Technical Note

Project:	P14-332 Glapwell		
Subject:	Site Access Technical Note		
Prepared by:	Jack Lindsay – Senior Transport Planner	Date:	16 Jan 2020
Authorised by:	Nick Smith – Principal Transport Planner	Status:	For Issue
Document Ref:	14332-RLL-19-XX-RP-S-501B	Revision:	P02

A technical note has been prepared in order to respond to Derbyshire County Council (DCC) highway's formal consultation response on planning application ref: BOL/19/00583/OUT - development for up to 65 no. dwellings on Land to the rear of 7-53 Mansfield Road, Glapwell.

Appendix B – Drawing 14332-RLL-19-XX-DR-D-5001E

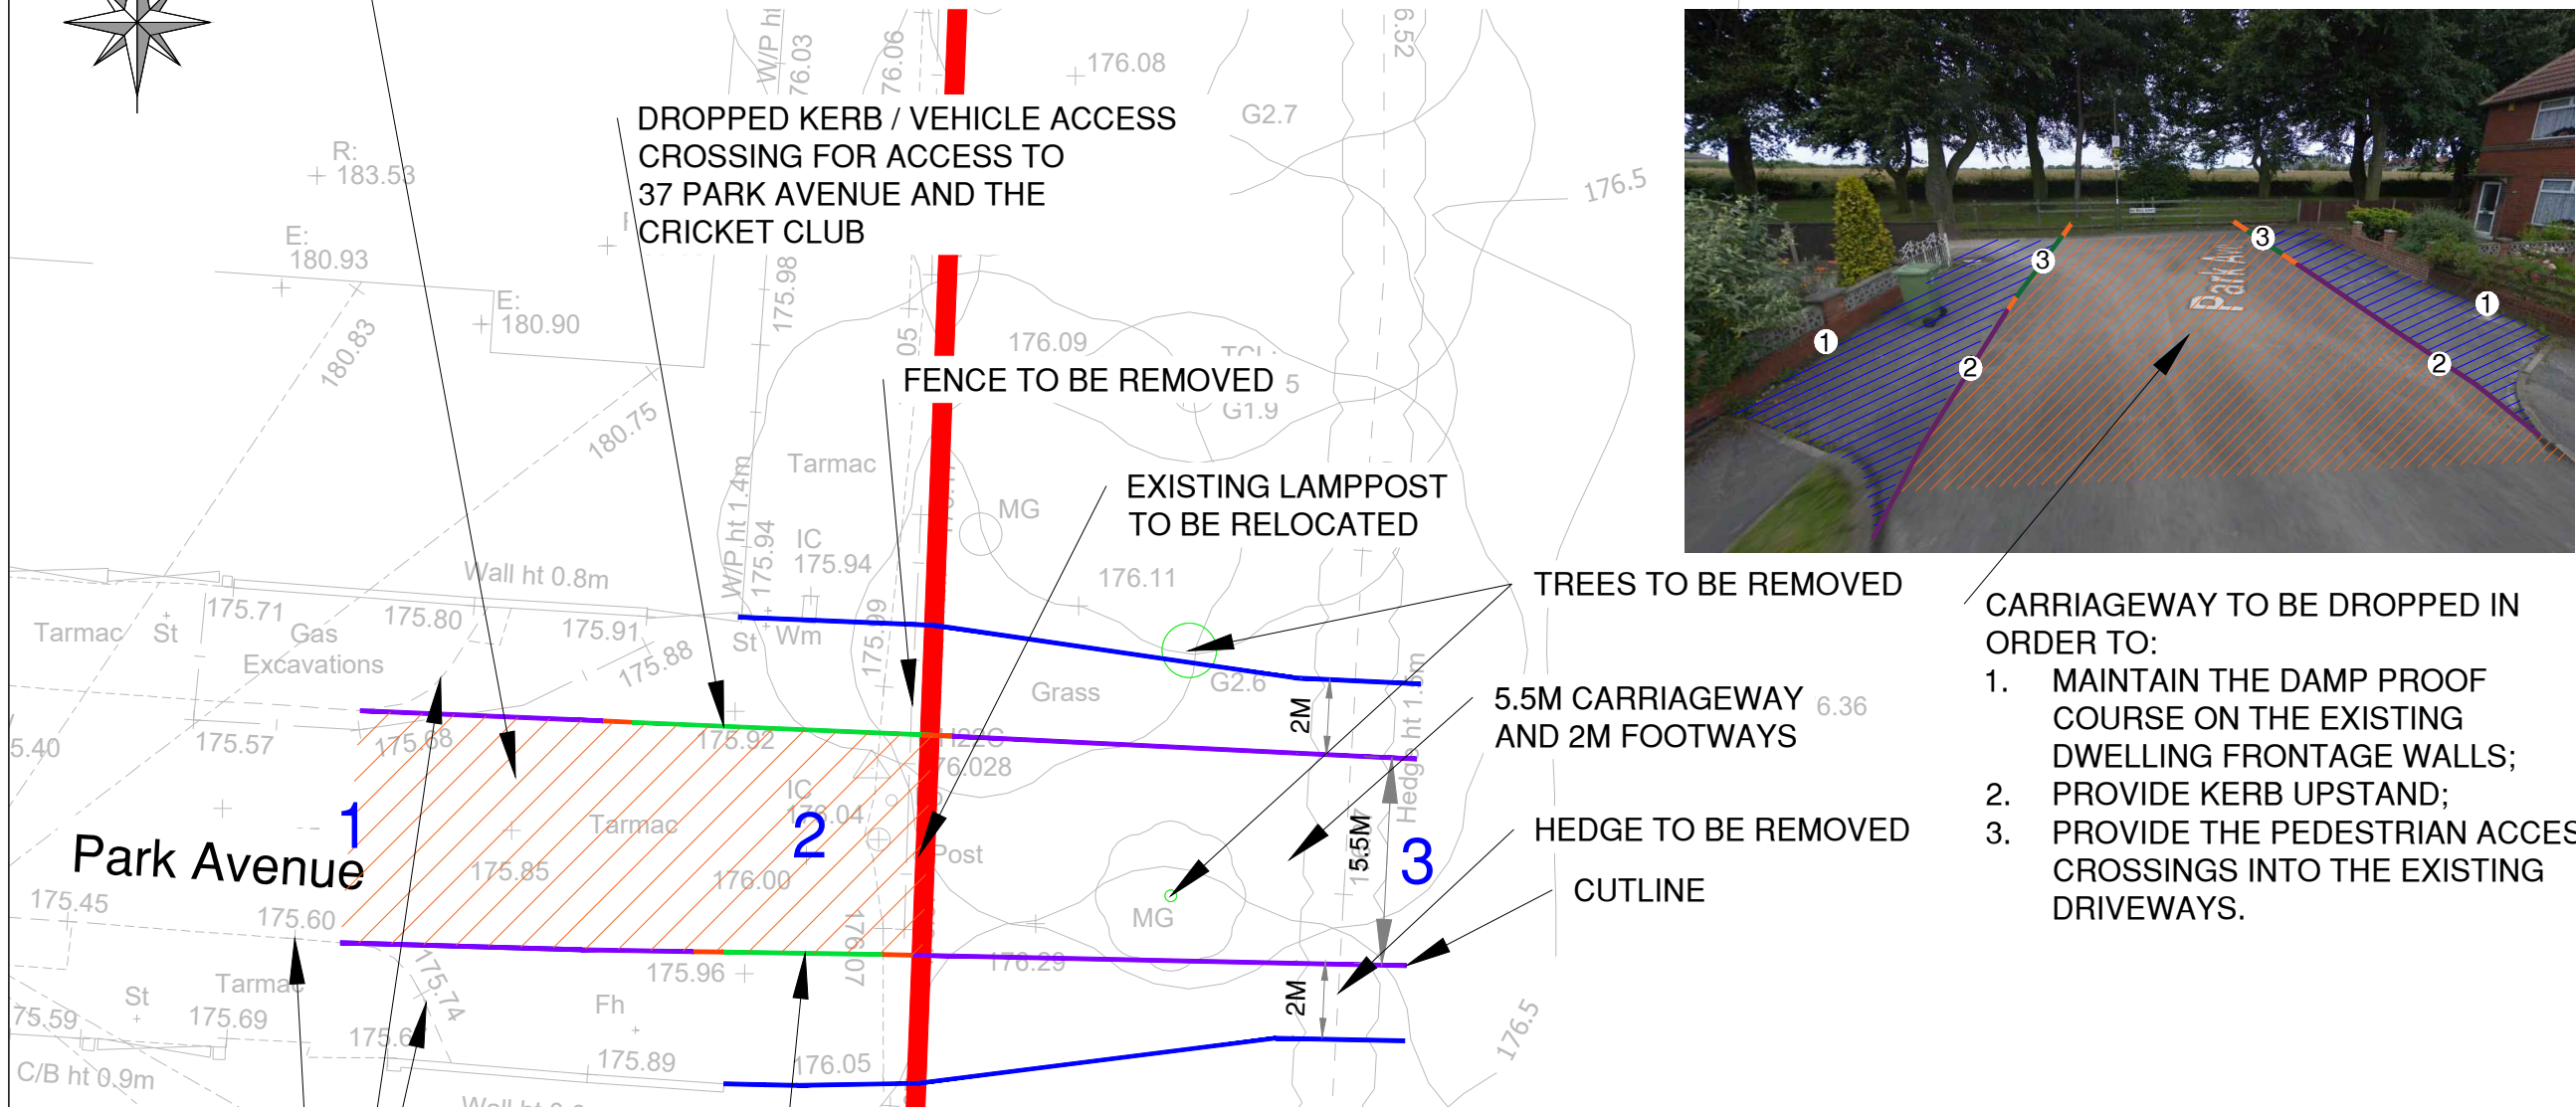
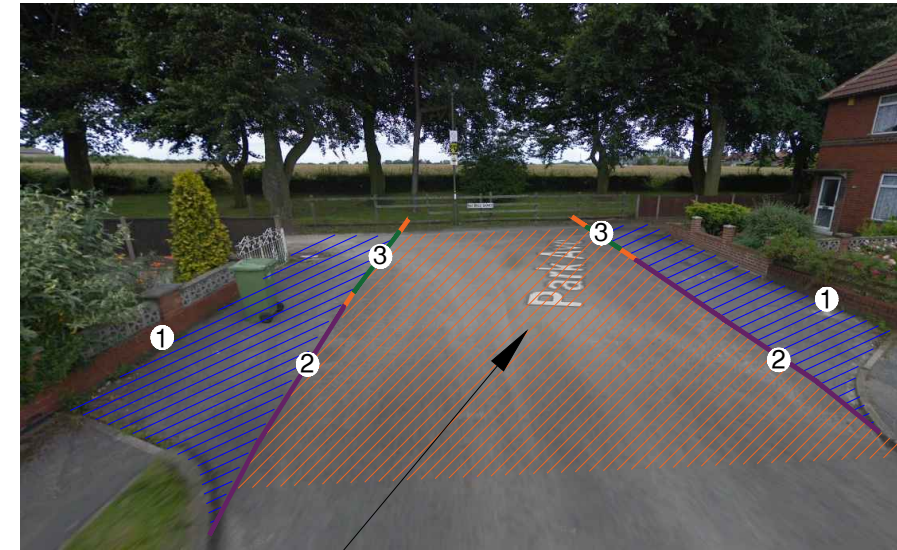
“As access is not a reserved matter, the Highway Authority would expect a detailed design of the initial length of proposed extension to Park Avenue on an accurate topographical survey base to be submitted demonstrating requisite revisions to the existing highway e.g. removal of widened carriageway, extension of existing footways, accommodation works at existing driveways currently level with the carriageway, etc.”

I've not had opportunity to revisit this site to make a specific assessment of feasibility of the proposals and have been reliant on Streetview images however, in the first instance, I'd recommend that the long section is extended by around 20m and the proposed levels are modified to remove any flat section. Creation of a marked 'dip' in the vertical alignment will need to be avoided.

My immediate thoughts are that the long section should be extended to demonstrate the level of the existing road on approach to the proposed revisions and that introducing a 'flat' section of carriageway will not be acceptable. Vertical curves between changes in grade should also be demonstrated.

I would expect the Technical Note to include details to satisfactorily address these issues as well as demonstrate the kerb upstand achievable at the vehicular accesses together with the footway cross falls.

The proposed solution isn't one I've come across before but may well work. It would probably be useful to submit a Longitudinal Section of existing and proposed levels just to give an indication of the change between the approach on the existing road, through the lowered length and potentially beyond into the site.

A topographical survey has been carried out and subsequently a more detailed access proposal has been produced, presented in drawing **14332-RLL-19-XX-DR-D-5001E** contained within **Appendix B**.

- Dropped, transition and raised kerbs are illustrated, access will be maintained to properties 37 and 40 Park Lane, and the cricket club via pedestrian access crossings.
- The existing footways will be extended and tie into the proposed development 2m footways;
- Two trees, a section of hedgerow and a fence are to be removed;
- The lamppost at Park Avenue's eastern extent will be removed (and potentially relocated);
- The existing carriageway is circa. 6.2m close to Park Avenue's existing eastern extent and will narrow to 5.5m within the Site.

The proposed carriageway is illustrated as ~0.22m lower than the existing carriageway level outside the cricket club access. The carriageway would then rise to existing ground level within the site at a maximum gradient of 1:12.

There is a slight 'dip' in the carriageway, albeit the max difference between the existing and proposed levels is only ~.22m. The proposed levels no longer contains a flat section. I have illustrated the proposed carriageway returning to the existing levels at a gradient of 1:12, obviously the gradient could be more gradual than 1:12, which would further remove the perception of a "dip", given the ground level drops slightly further into the site as the green line illustrates on the attached. This would be set out at detailed design stage.

At the western extent of the dropped kerb access to 27 Park Avenue and the Cricket club, the proposed carriageway would be ~0.15m lower than the existing carriageway level. The height of the proposed footway would replace the existing carriageway height and therefore the DPC would not need to be altered.

Thanks for the comments. I have added a longsection to the drawing (see attached), it illustrates how the existing carriageway rises east of the existing footway extents and how the road could be regraded east of this point. The carriageway would then rise at a max 1:20 gradient and return to existing levels ~12.7m east of the existing Park Avenue extent.
